HINWEIS zum Anschluss der GU-Anbausets A-Öffner und A-Öffner servo

Temporäre Änderung der Aderbelegung beim A-Öffner-Kabel

NOTE concerning the connection of GU A-opener kit and A-opener servo kit

Temporarily modified wire allocation of A-opener cable

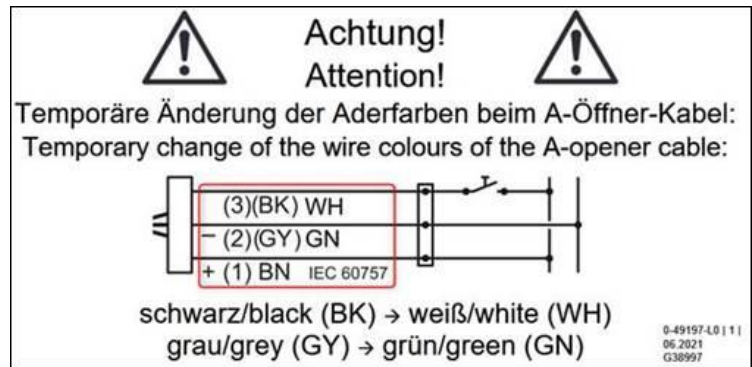
Aufgrund der Materialverknappung am Weltmarkt muss übergangsweise auf ein Anschlusskabel mit geänderter Adernfarbe ausgewichen werden. Nachstehende Übersicht bietet eine Übersetzung zum Anschluss.

Funktion	A-Öffnerkabel Übergangslösung	A-Öffnerkabel GU Standard	SECUREconnect 50 / 200
GND	GN	GY	GS
12 V AC / 12-24 V DC	BN	BN	VS
Steuerimpuls	WH	BK	90

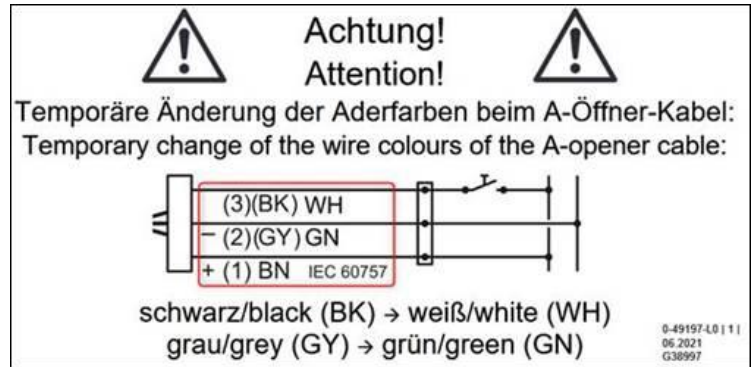
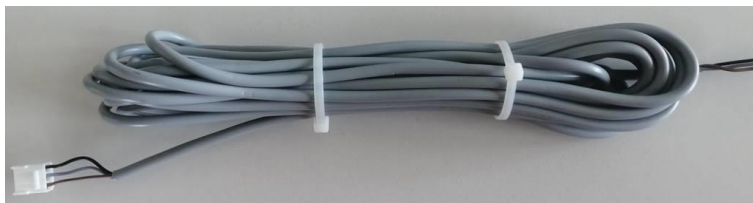
Due to material shortage, we have to switch temporarily to connection cables with another wire colour. Please see the following overview for further information.

Function	A-opener cable, interim solution	A-opener cable, GU standard	SECUREconnect 50 / 200
GND	GN	GY	GS
12 V AC / 12-24 V DC	BN	BN	VS
Control pulse	WH	BK	90
